RE: Committee Meeting #1 – Kick-off

**DATE:** June 13, 2003  
**RE:** Committee Meeting #2 – Analysis and Planning Concepts

**RE:** Committee Meeting #4 – Preferred Plan

Figure A.1: April 15, CHASS Keyplans

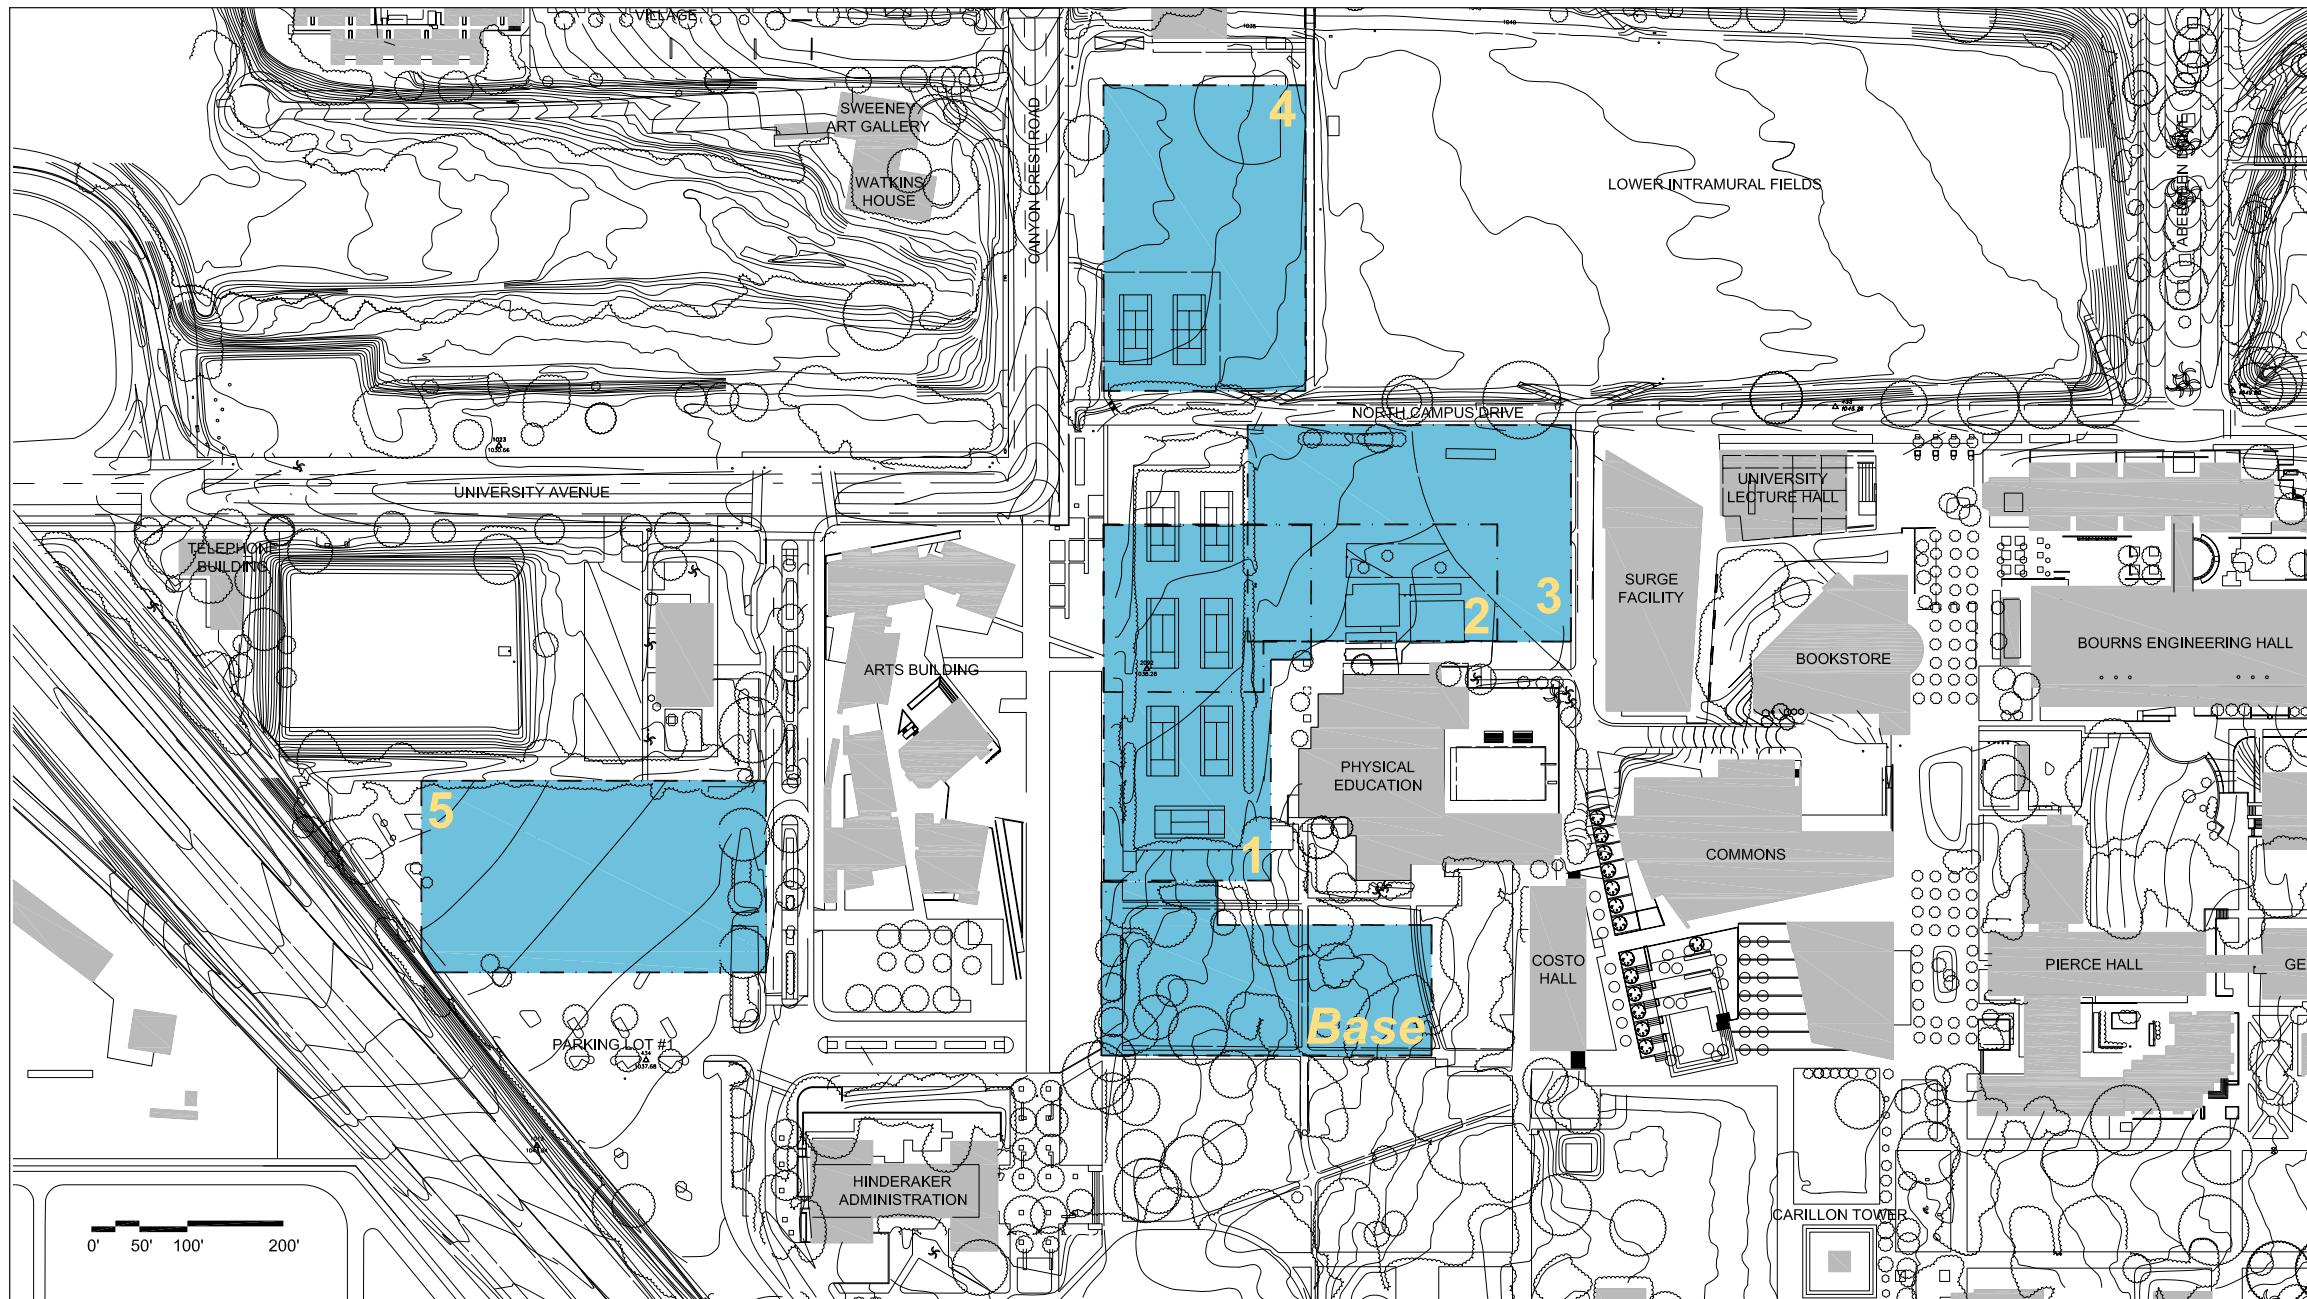
1.8 Chancellor Córdova posed the question of possible development around Site #1 if selected for the CHASS; could additional buildings be accommodated adjacent to the CHASS in the future? Will Dann noted that by sliding the building footprint slightly to the south, an additional building could be accommodated adjacent to the terminus of University Avenue. Doug Macy supported this move, noting that shifting to the south would register the CHASS more strongly with the Arts Mall, furthering defining and strengthening this axis.

2.0 The question was posed if Site #1 was moved south, would it compromise what could be built at the base condition site in the future; would it necessitate a reduction in square footage (sf)-available on the base condition site? Will Dann estimated a reduction from 100,000 sf gross to 80-90,000 sf gross. Doug Macy stated that careful work with the selected CHASS I&R architect would be necessary to ensure that the potential for a quality relationship with a future building at the base condition site was retained.

2.6 Dean O'Brien expressed concern with Site #1's ability to provide a monastic experience desired to complement the program of both the Center for Ideas and Society and the ceremonial arbor that will have very private functions. Doug Macy acknowledged this challenge, noting possible difficulties accommodating service without negatively impacting the privacy of these programmatic needs. He supported the need to continue interfacing with the CHASS I&R architects as the chosen alternative siting is explored.

3.1 The group posed the question of utilities located at the northwest corner of Site #1; if building is moved south does this solve the problem? Doug Macy clarified that moving the footprint south of the pump station would alleviate the significant cost of relocating these facilities, but they remain a challenging issue located at such close proximity to the building entry.

Figure A.2: June 13, Base Planning Scheme

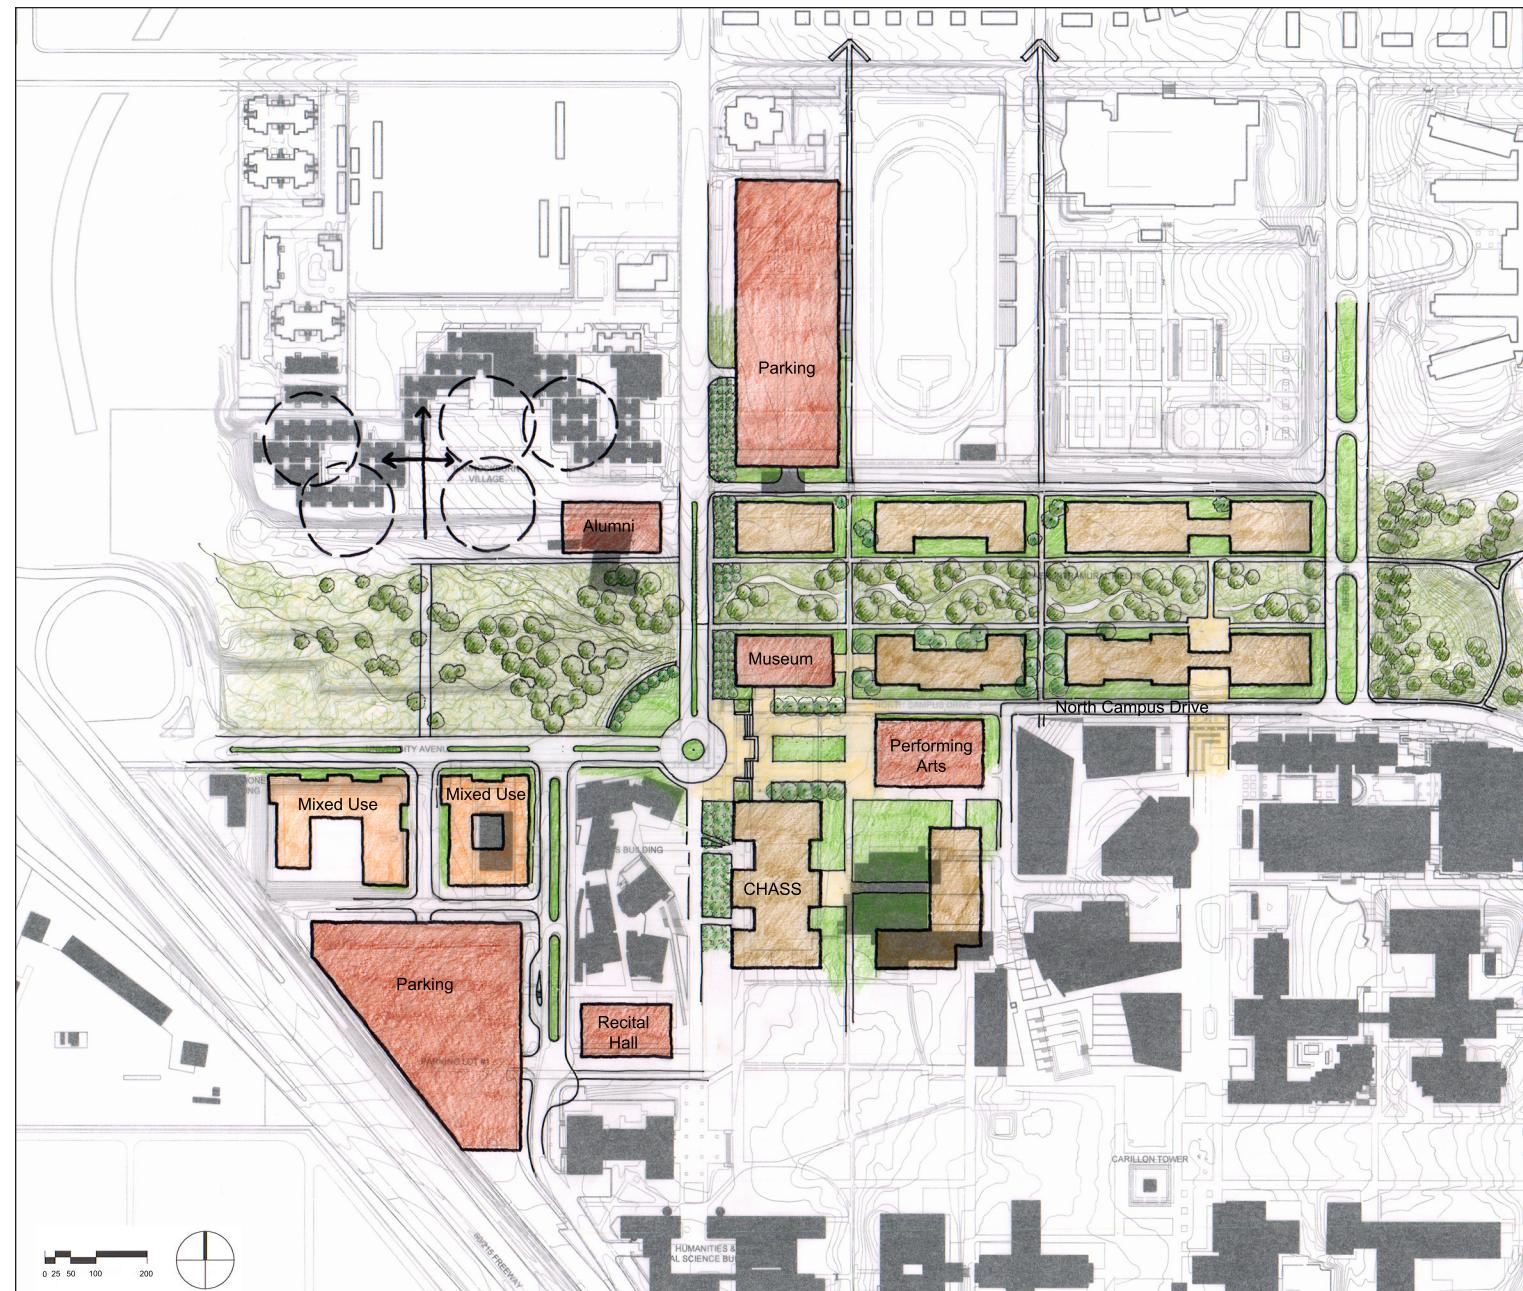
- This scheme seems to leave a lot of land open; review densities across all schemes
- With more open space remaining open, we may be able build higher (hold below 6 stories)
- Provide for ADA access; create bridge system across “arroyo”
- Would this concept accept the natural flow of the arroyo rather than having to pipe it; no--due to flooding implications, need to be flexible in use of landscape, unpredictable nature of arroyo floods. This area could however be used for localized stormwater strategies. Explore multiple uses for this openpace including outdoor teaching, outdoor performance space as well as for stormwater.
- Care should be taken that the Alumni and Visitor Center not encroach on Bannockburn.

Figure A.4: June 13, Alternative #2

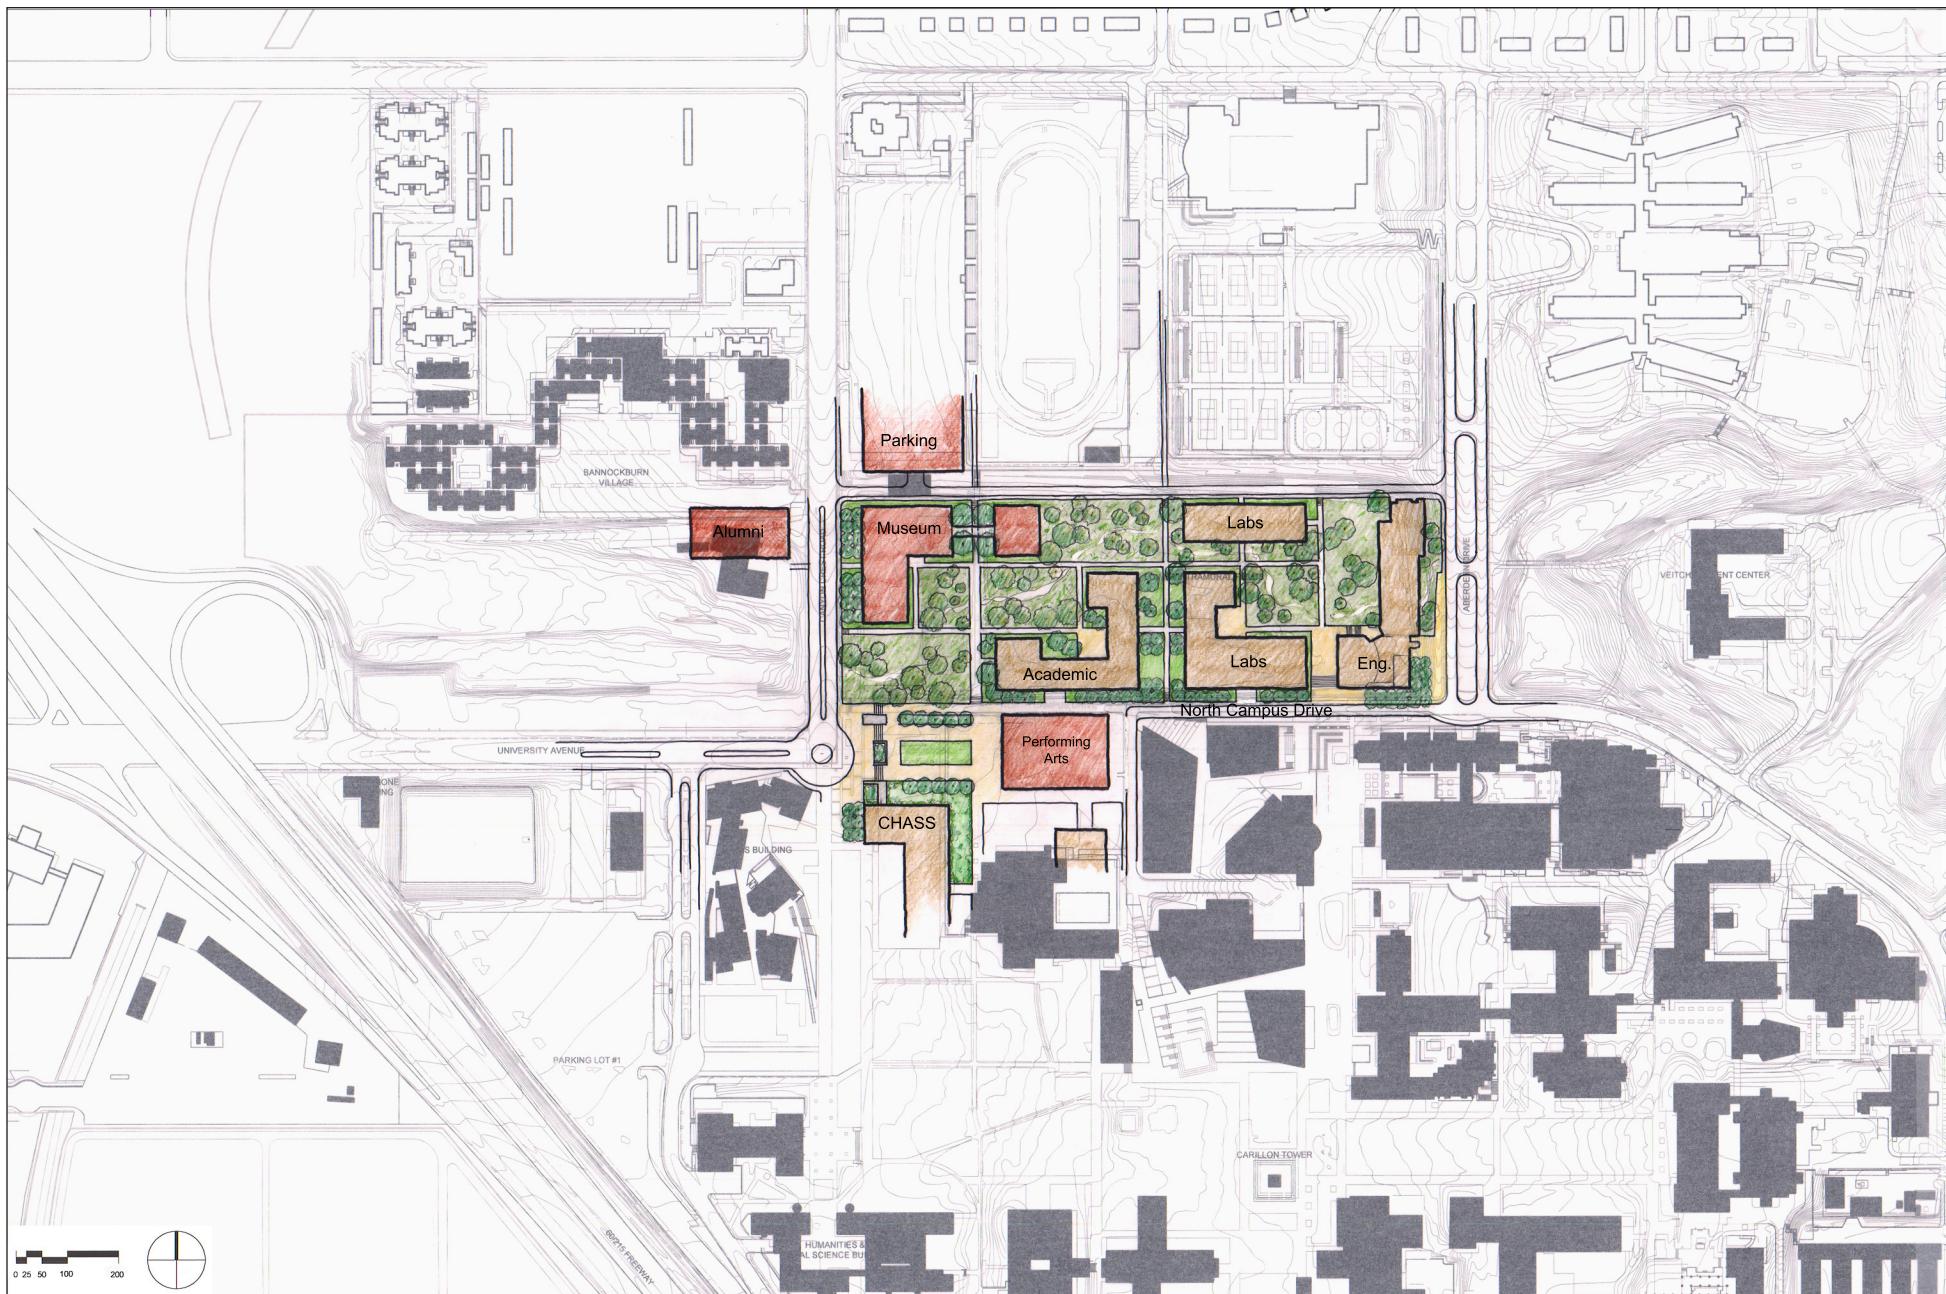
- Lose sense of Arts Complex and the “arroyo” concept is not as strong as the base scheme either.
- The Performing Arts at the terminus provides a great presence for the entry, but may provide issues with providing adequate service.
- This location for the Performing Arts may also create conflicts with the flow of pedestrian from the Commons north. Explore Museum/Alumni combination here with a terrace at the east side.
- Consider Performing Arts near parking but do not completely block “arroyo” concept.

Figure A.12: July 22, Alternative #3

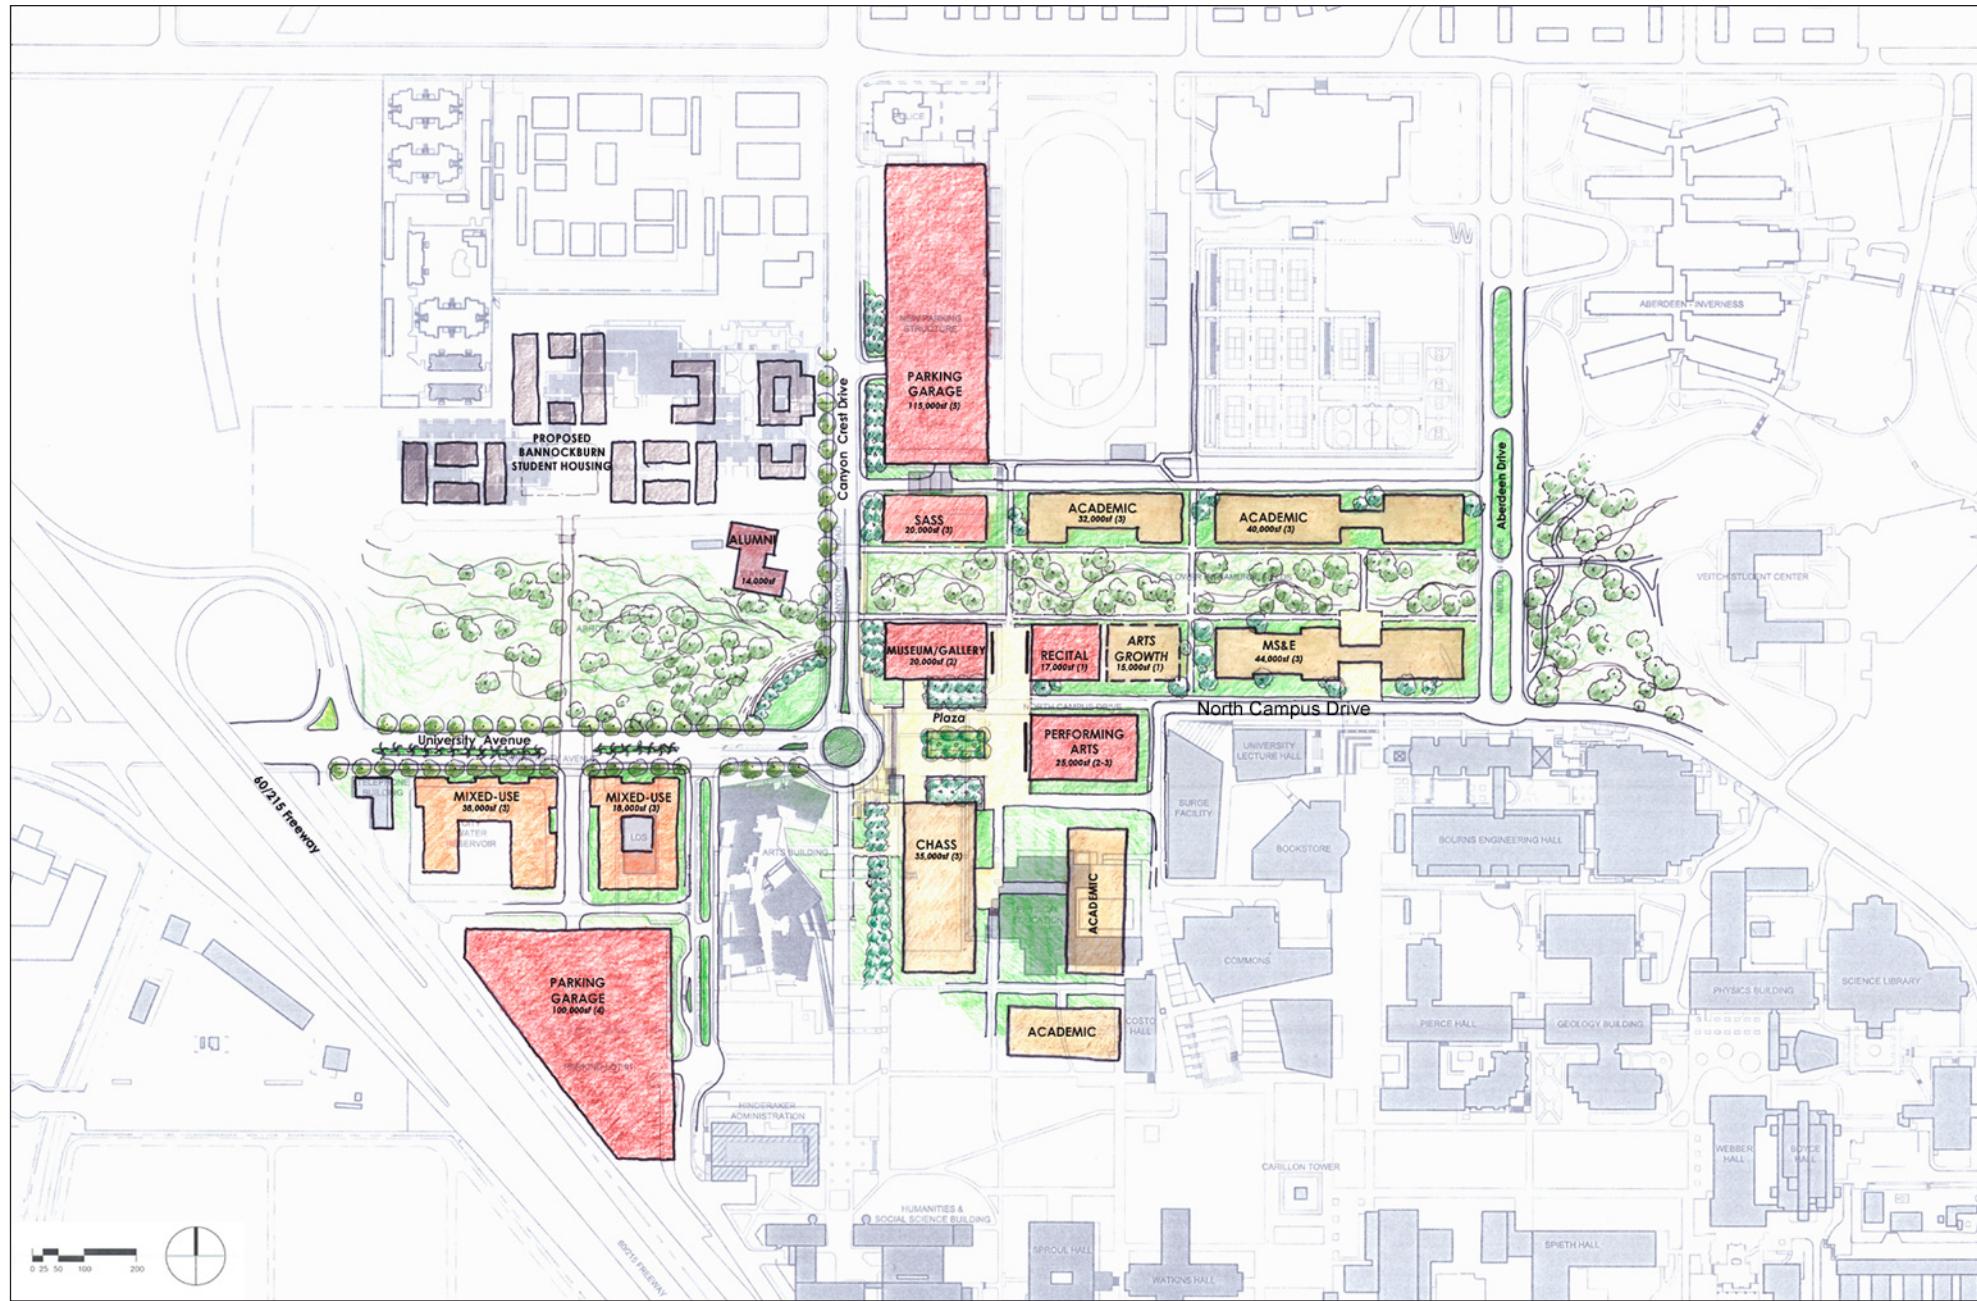
1.7 Dean O'Brien questioned the positioning of the Performing Arts in Scheme 4 as related to interrupting the flow of the "arroyo" concept.

Thom noted that the DRB had responded positively to this scheme as it keeps a diagonal view open across the plaza and into the arroyo. He also noted the potential for the naturalized planting scheme to be reflected in the plaza planting.
